STATE OF WASHINGTON
DEPARTMENT OF ECOLOGY

Re: Opinion pursuant to WAC 173-340-515(5) on Remedial Action for the following Hazardous Waste Site:

- **Site Name:** Coit Services
- **Site Address:** 16750 Woodinville-Redmond Rd NE, Woodinville, WA 98072
- **Facility/Site No.:** 36189742
- **Cleanup Site ID No.:** 16672
- **VCP Project No.:** NW3377

Issue Presented and Opinion

Enclosure A Figure 2

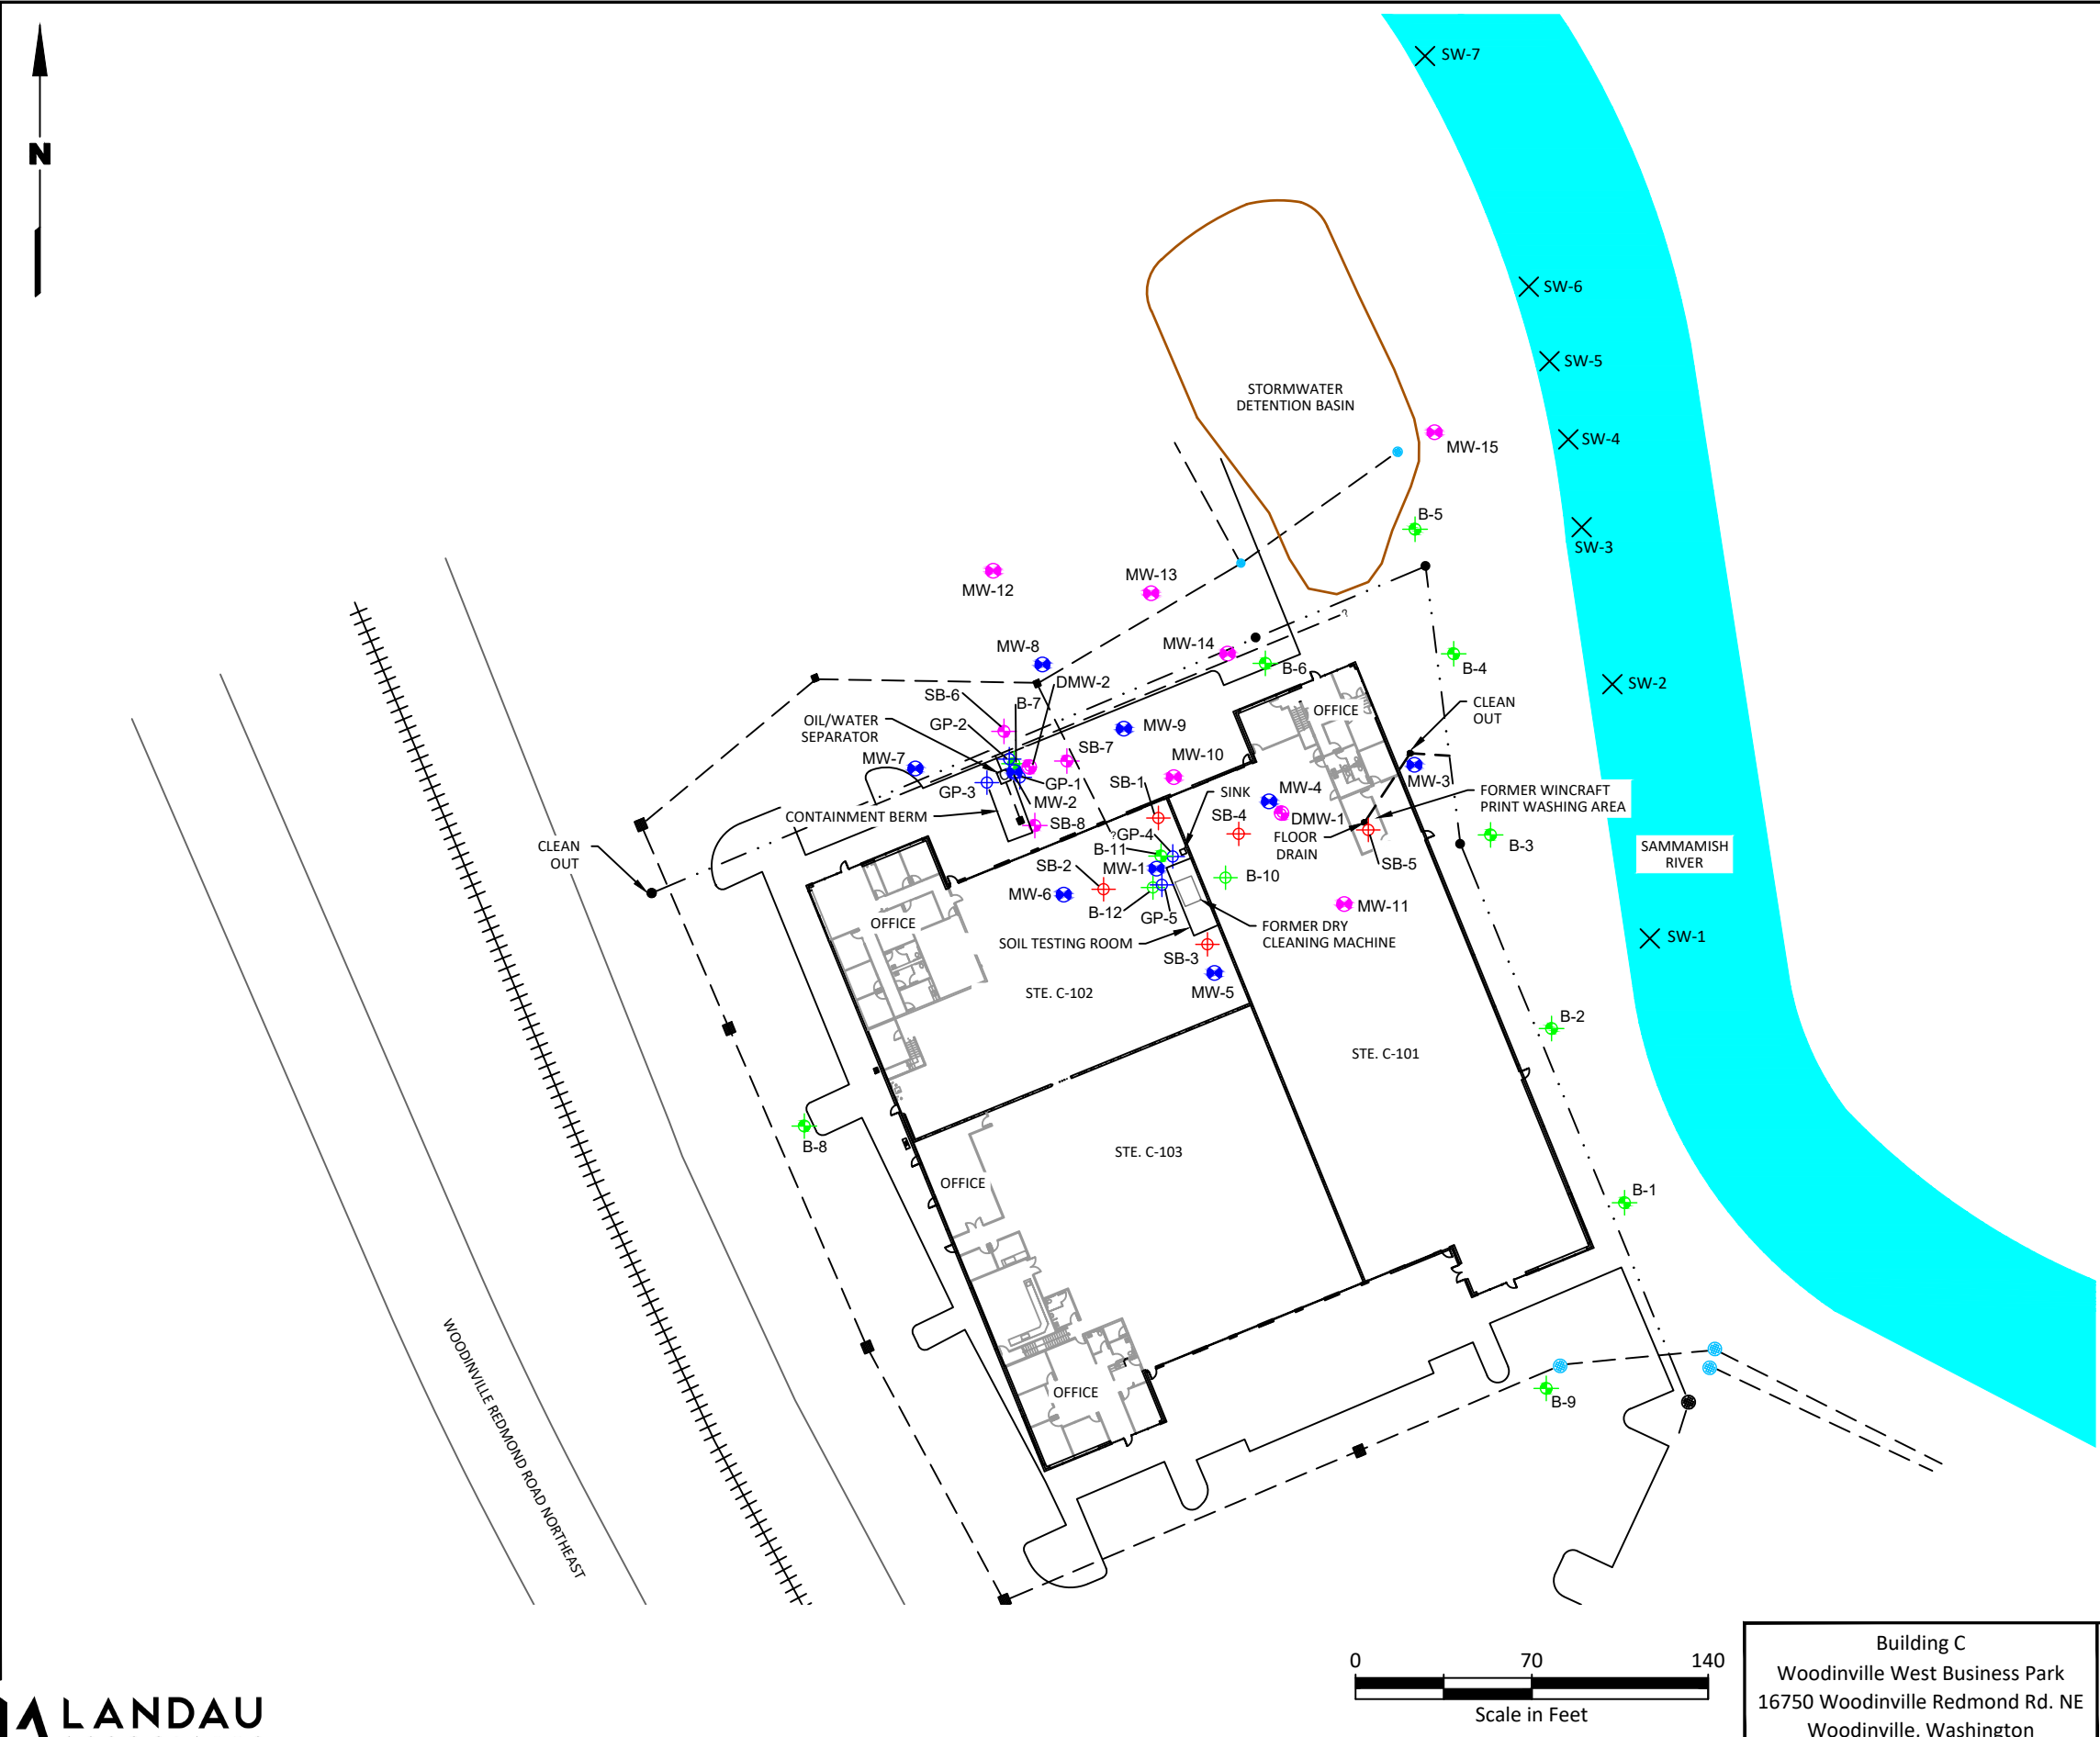
A total of five temporary and seventeen permanent monitoring wells were installed at the Site from 2019 to 2023 to characterize the extent of HVOCs in groundwater (GP-1 to GP-5, MW-1 to MW-15, DW-1 and DW-2; see **Enclosure A, Figure 2**). Based on the results of these investigations, two contaminant plumes were identified associated with the location of the oil-water separator and former dry-cleaning machine (see **Enclosure A, Figure 4**). Groundwater samples collected from MW-1, MW-2, MW-3, MW-4, MW-7, MW-8, MW-9, MW-13, MW-14, and MW-15 contained vinyl chloride above the Method A cleanup level. No other wells at the Site contained any HVOCs above their respective Method A or B cleanup levels. The extent of groundwater contaminated with HVOCs is defined vertically and to the west and south.

Ecology recommends installing additional monitoring wells to the north and south of MW-15 to fully constrain the limits of HVOCs in groundwater in this portion of the site. See section 2 below for further discussion of groundwater cleanup levels and points of compliance with respect to groundwater-surface water interactions.

In August of 2023, a total of seven surface water samples were collected from the Sammamish River, located downgradient of the releases (see **Enclosure A, Figure 2**). None of the samples contained HVOCs above laboratory reporting limits. Based on the results of additional recommended groundwater sampling discussed above, additional surface water sampling may be necessary at the Site.
